MANDATORY UPDATE INFORMATION

Date: 10/20/21
To: STXDF Ride-On Trowel Owners
From: Multiquip Product Department
Subject: Spider Retention Hardware — **Mandatory Update**

Service Bulletin

STXDF Spider Retention Hardware Update

Figure 6. Remove Left-Side Spider Screws

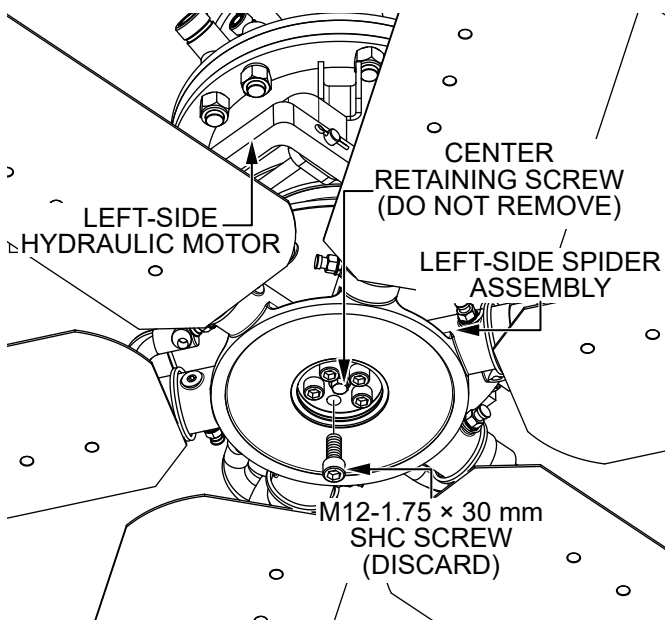
2. Remove and discard the five existing M12-1.75 × 30 mm SHC screws (Figure 6) securing the left-side spider assembly to the bottom of the left-side hydraulic motor.

DO NOT remove the center retaining screw (hex flange type) from the spider assembly. Only the 5 surrounding screws (with socket head caps) are to be replaced.

Figure 7. Clean Screw Holes

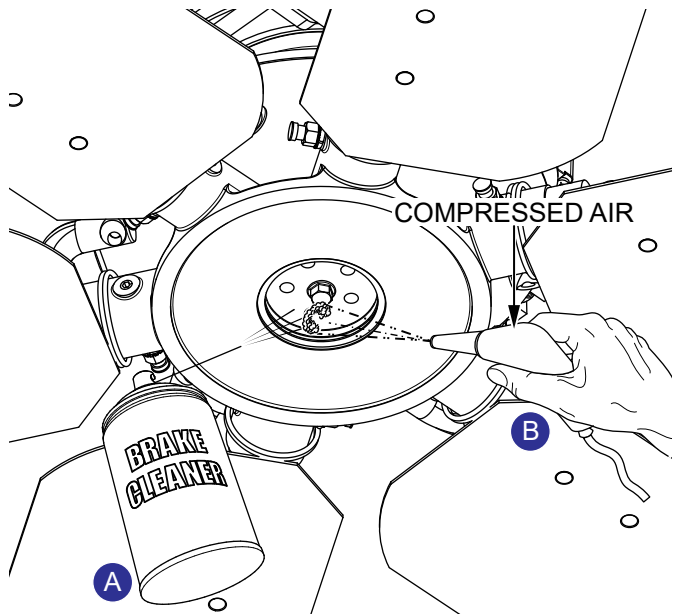
3. Using an M12 × 1.75 tap, recut the threads of the empty screw holes to remove any Loctite residue.
4. Use brake cleaner (Figure 7A) to clean out any debris from the empty screw holes. When finished, use compressed air (Figure 7B) to remove any remaining residue.

Make sure the screw holes are **clean and completely dry** before installing the new screws.

Figure 8. Apply Loctite 242 to New Screws

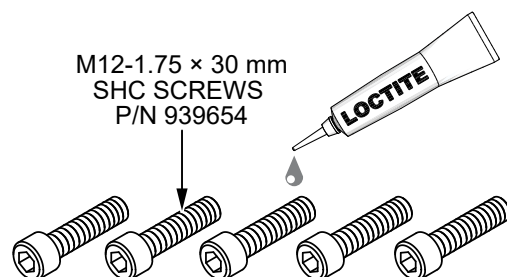
5. Apply Loctite Blue 242 (P/N 1477) to the threads on five new M12-1.75 × 30 mm SHC screws (P/N 939654). See Figure 8.

Figure 9. Install New Screws and Washer

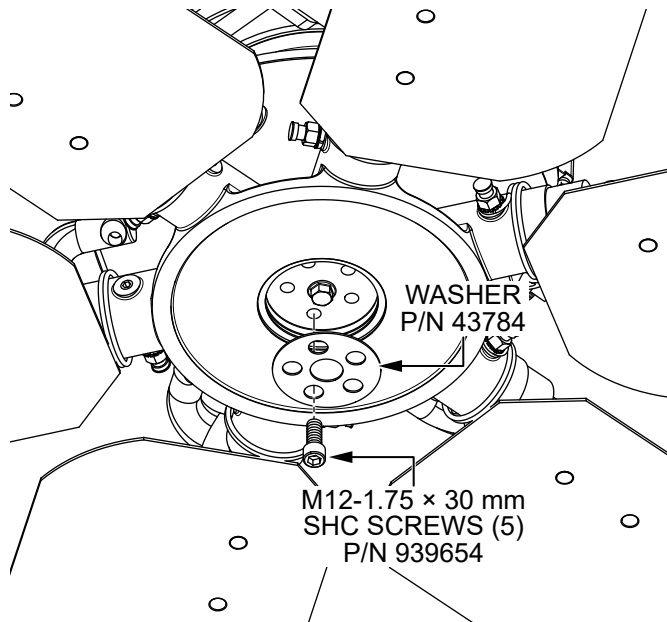
6. Install the five new M12-1.75 × 30 mm SHC screws (P/N 939654) with one washer (P/N 43784) as shown in Figure 9. Torque the screws in a star pattern to 40 lbf·ft.

7. Re-torque all five M12-1.75 × 30 mm SHC screws (P/N 939654) to 90 lbf·ft in a star pattern.
8. Reinstall the left-side spider hub cap plug.
9. Repeat steps 1–8 on the right-side spider assembly.
